FINAL PLAT LOT 1, BLOCK 1 CROSSINGS ADDITION

SITE PLAN		DATE 12/1/90	
HIGHWAY 205		T. WALTERS	
ROCKWALL, TEXAS		R212P000 DWG. ROTATED 60°00'	
SCALE 1"= 20'		JOB NUMBER 0	
SITE		REV.	
P1		0	
4-11111111 02

RACETRAC SITE PLAN - SH 205 NORTH OF IH-30 AND LAKESIDE CHEVROLET

Agenda Item: P&Z 91-1-CUP/SP/FP - Hold Public Hearing and Consider Recommending Approval of a Request From Racetrac, Inc., for a Conditional use Permit for a Building Not Meeting Materials Requirements and Approval of a Site Plan and Final Plat for a Self Serve Gas Station Located on SH-205 North of I-30

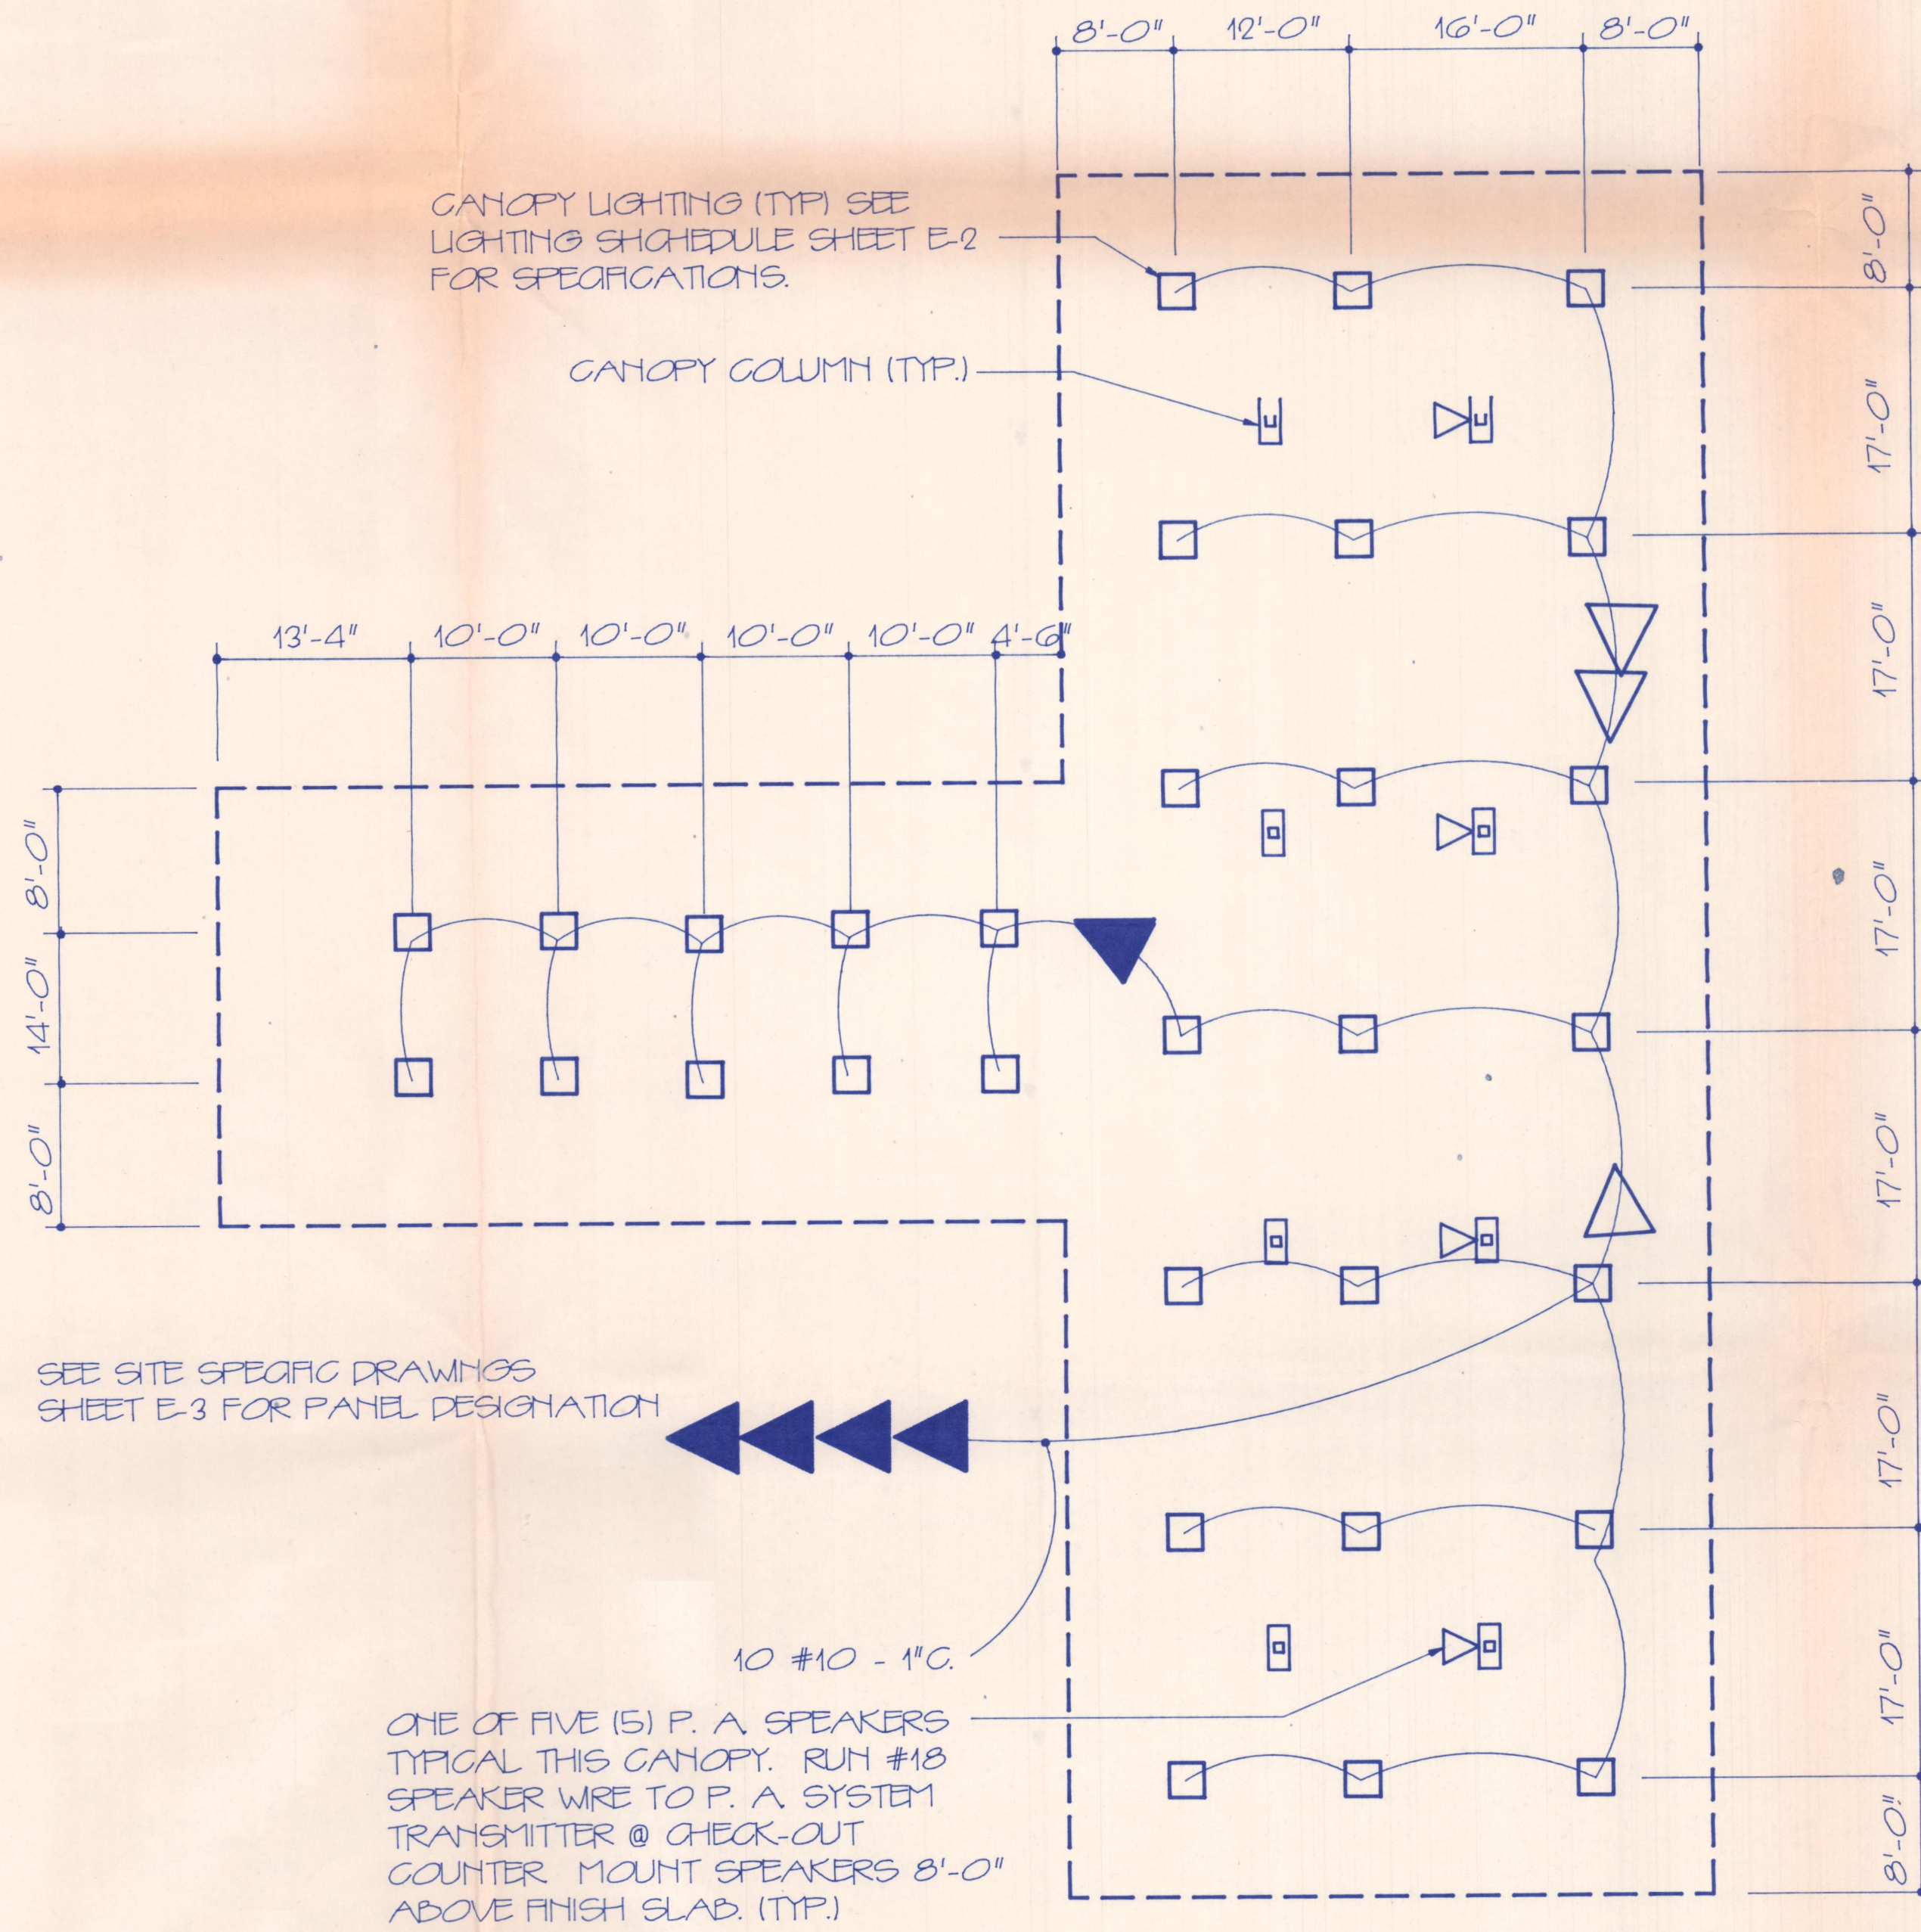
Canopy supports and sign support - They plan to use a stucco material to screen the metal supports for both the sign and canopy rather than brick. The stucco would be painted grey to match the building.

The Commission recommended approval of the site plan with the conditions that a parapet wall be constructed along the back of the building to match the other walls, and that the canopy supports and the sign pole be wrapped with the split face block to match the material used on the main structure.

3 FRONT ELEVATION
A-2 1/4"=1'-0"

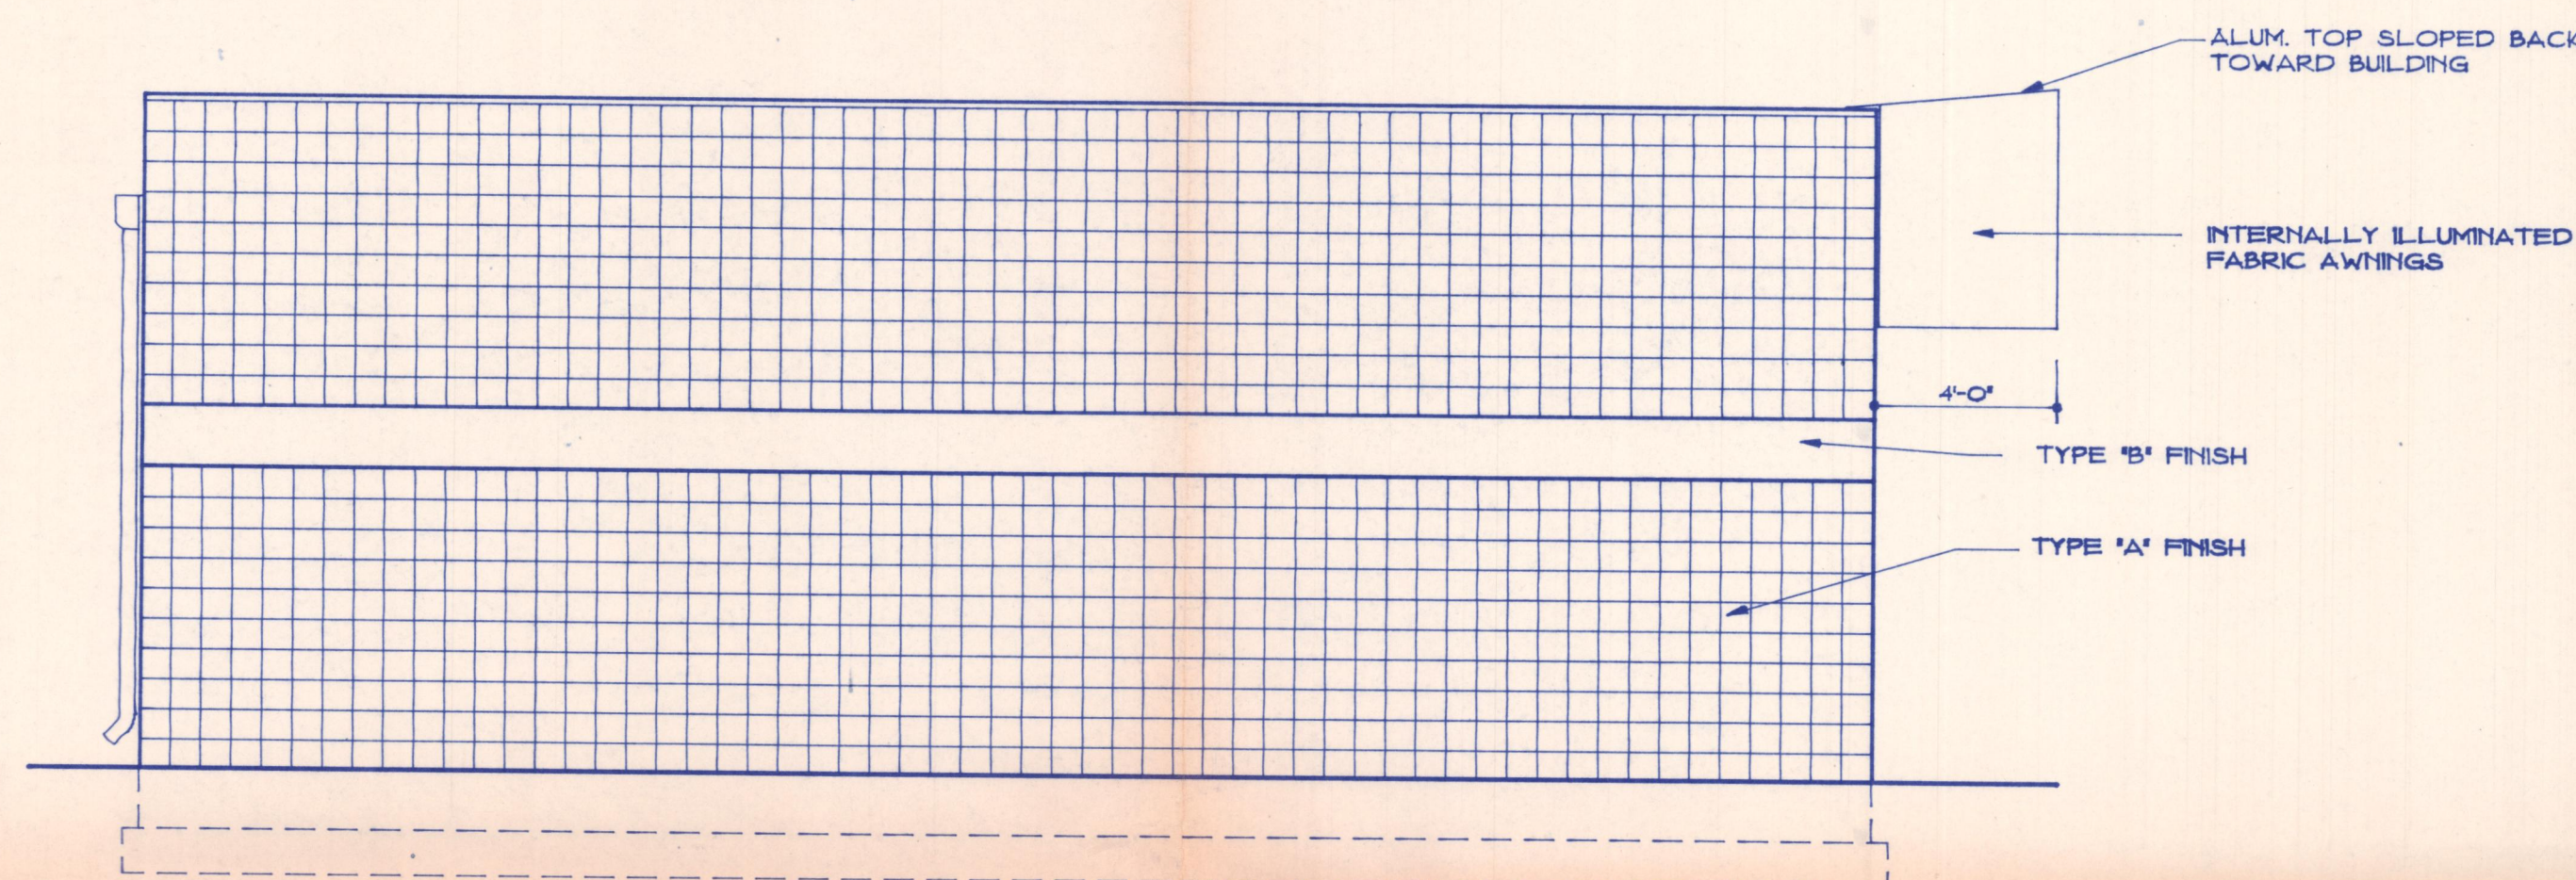
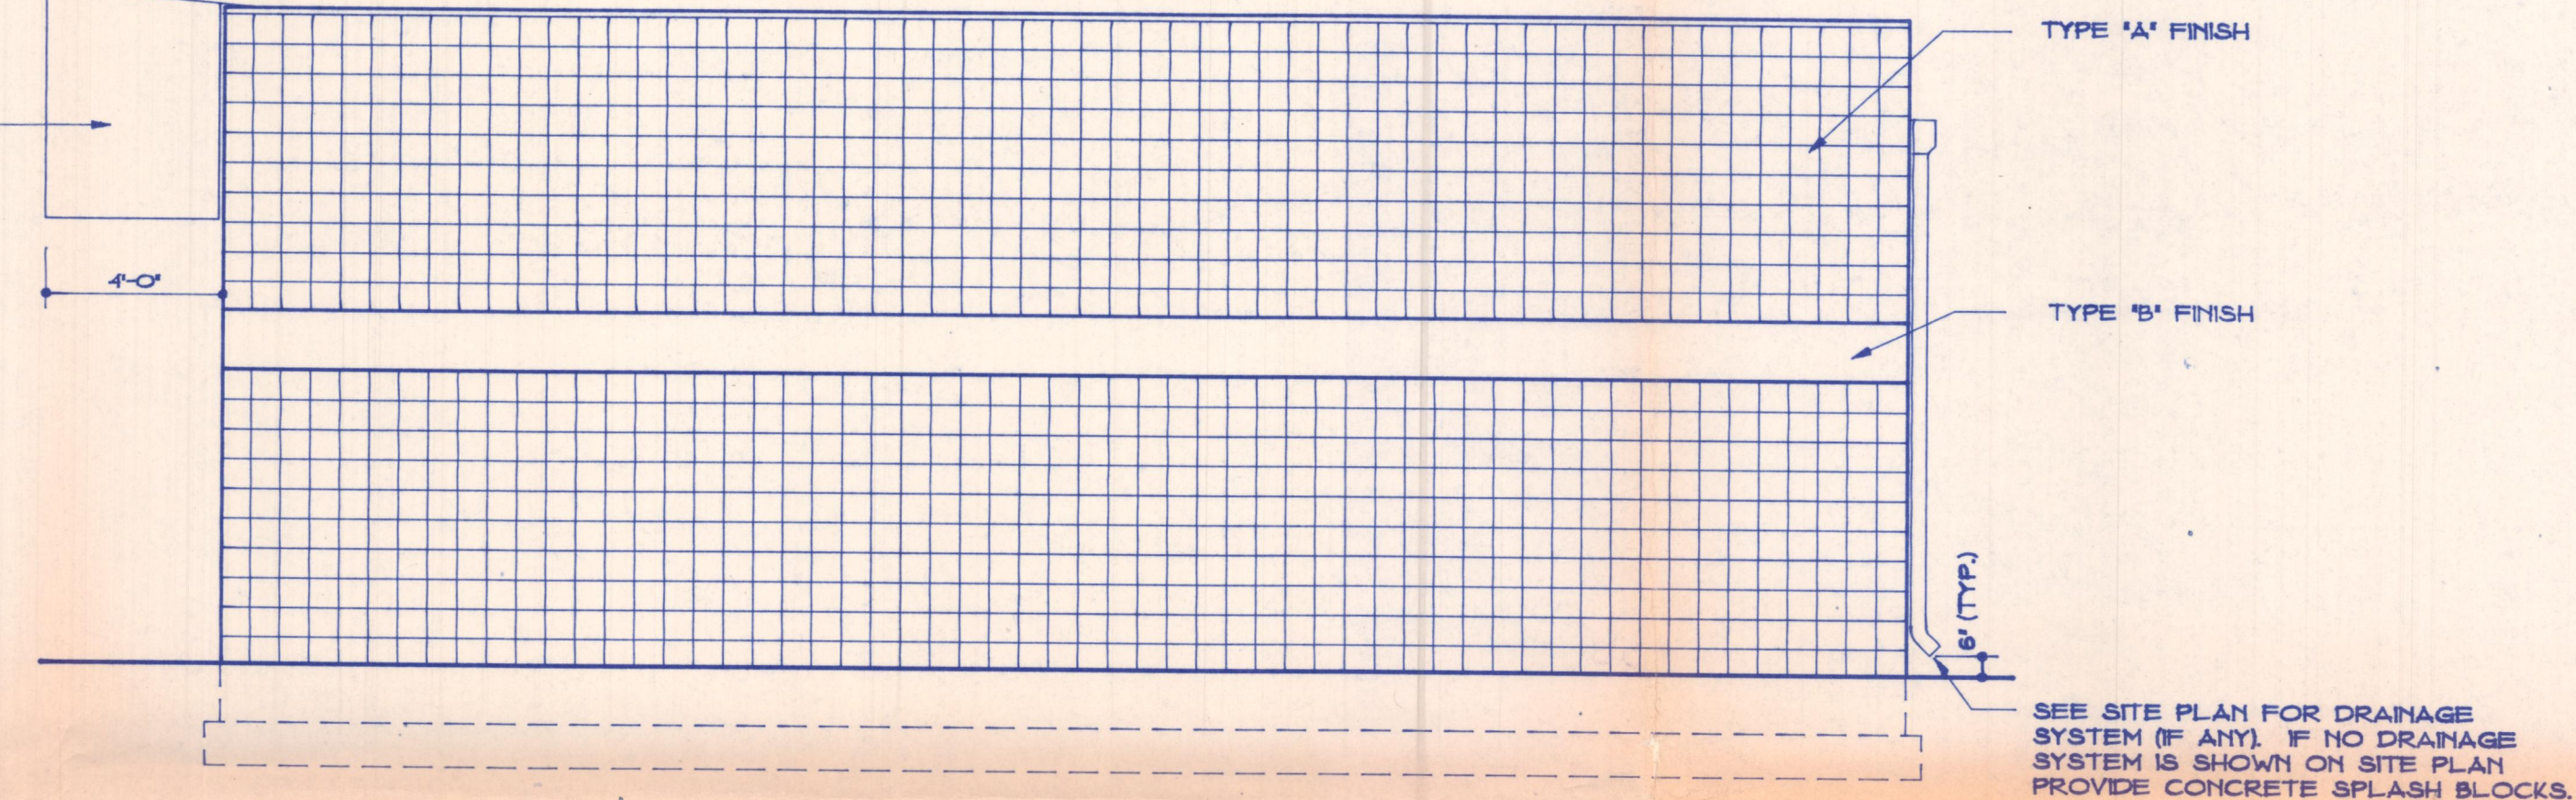
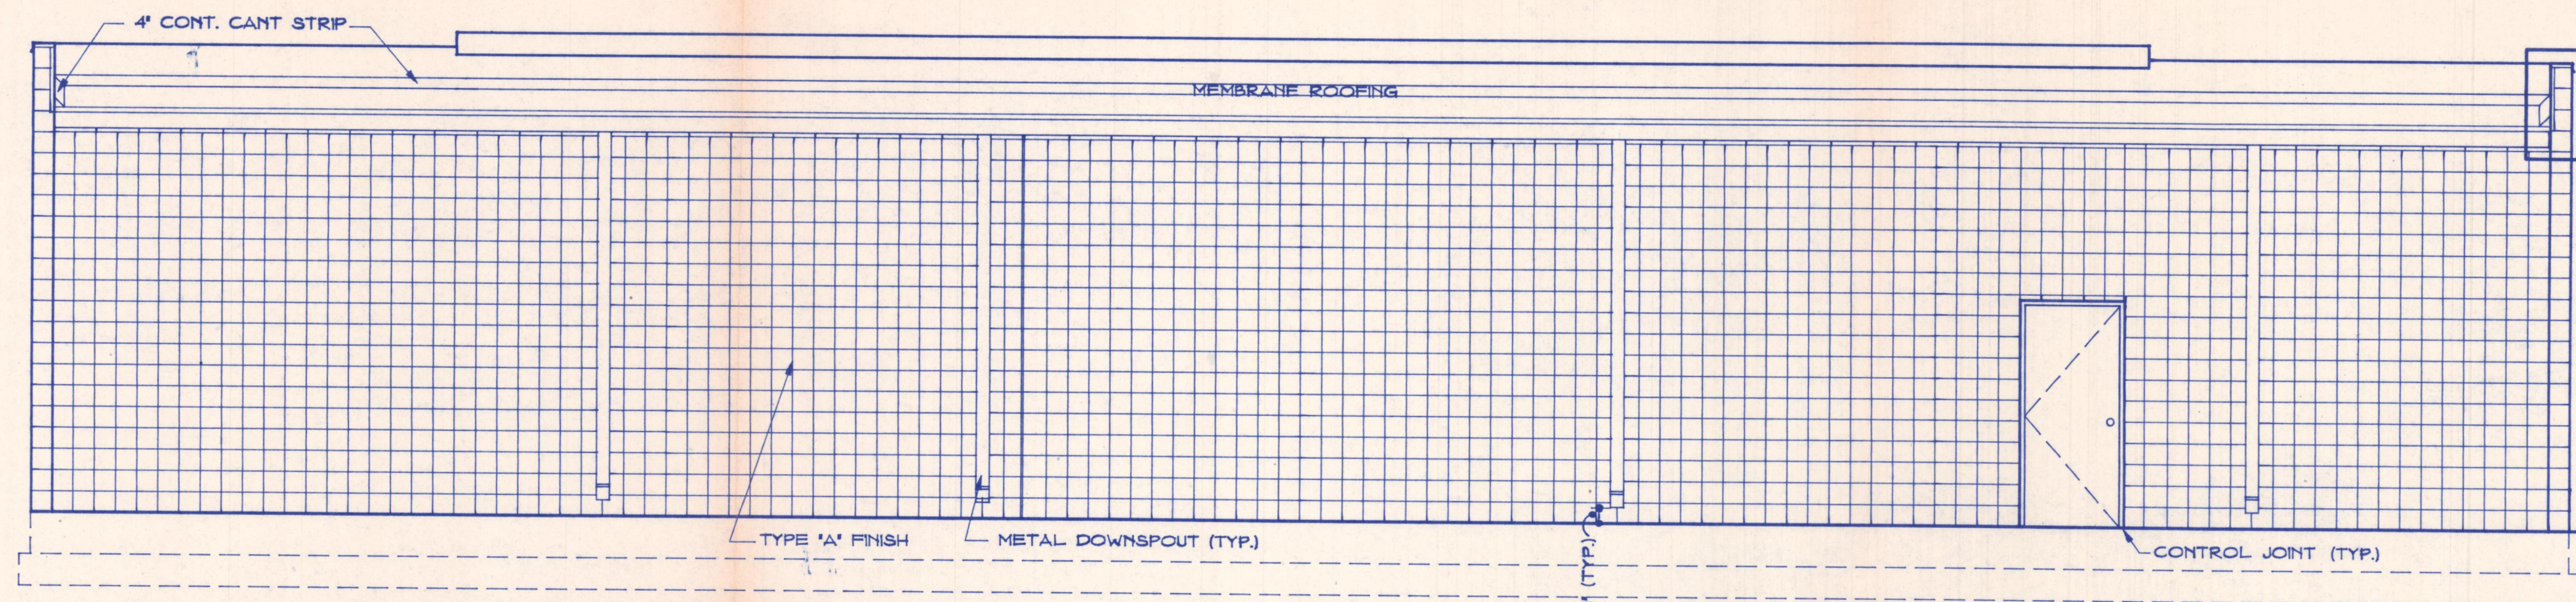
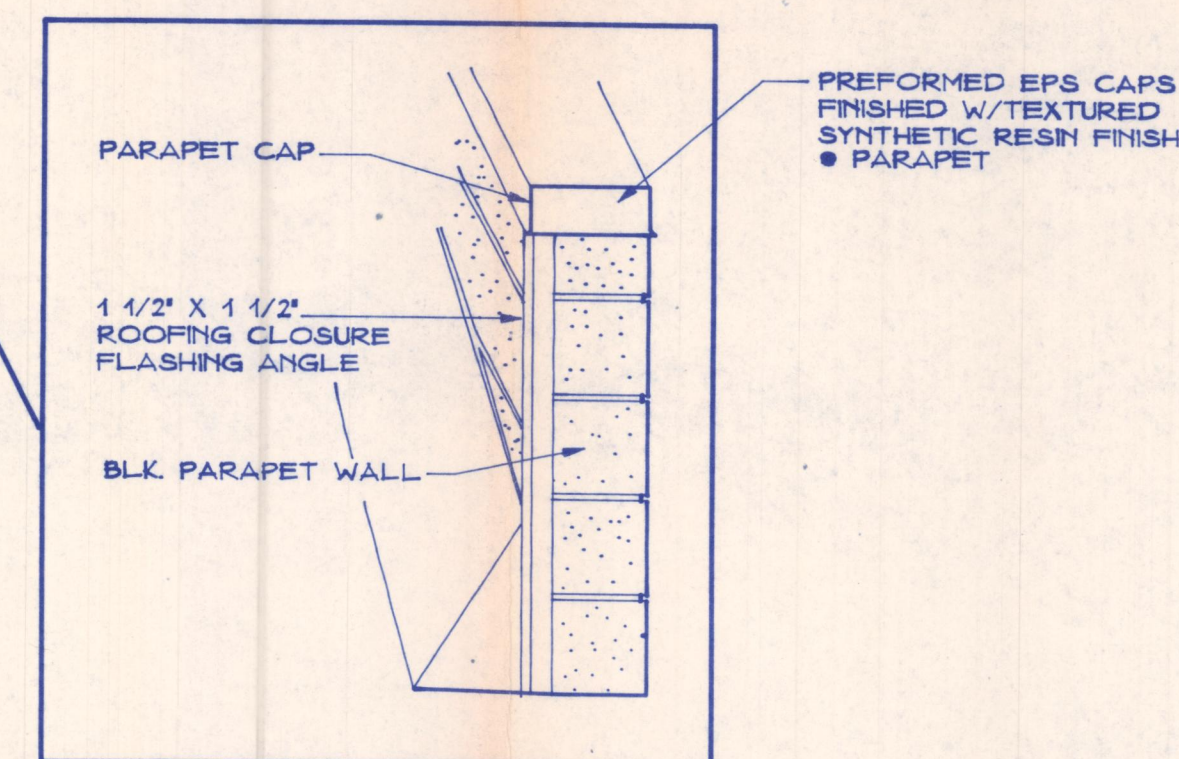
Building - the building is proposed to be constructed out of a concrete block material. This is very similar to the material used by Braum's for their building. This material does require a CUP to be used. They do not show a parapet wall along the back of the building but they are willing to put a wall along the rear. This should be included as a condition in the approval.
